Product Change Notice (PCN)

PCN Number: PCN-0450480R-01

Product(s) Affected: *MJ-3507*

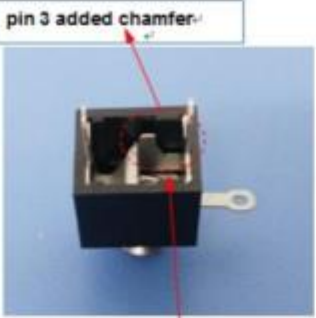
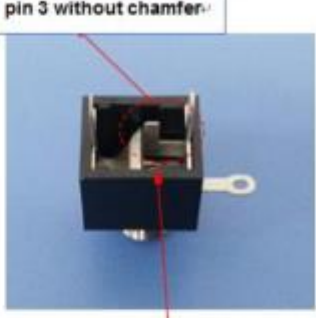
Reason(s) for Change: *The existing mold of pin 3 for MJ-3507 is unable to maintain efficient production. To ensure the quality and lead-time of production, a re-development of the mold has been processed. The new mold will optimize the design by increasing the chamfer of pin 3 inside the product. The electrical structure and function will remain the same. (The comparison photos are available below).*

New version	Current version
Back	 <p>pin 3 added chamfer.</p>	 <p>pin 3 without chamfer.</p>
	 <p>pin 3 is continuous piece, with cutting mark.</p>	 <p>pin 3 is separate piece, without cutting mark.</p>
	 <p>pin 3 added chamfer.</p>	 <p>pin 3 without chamfer.</p>
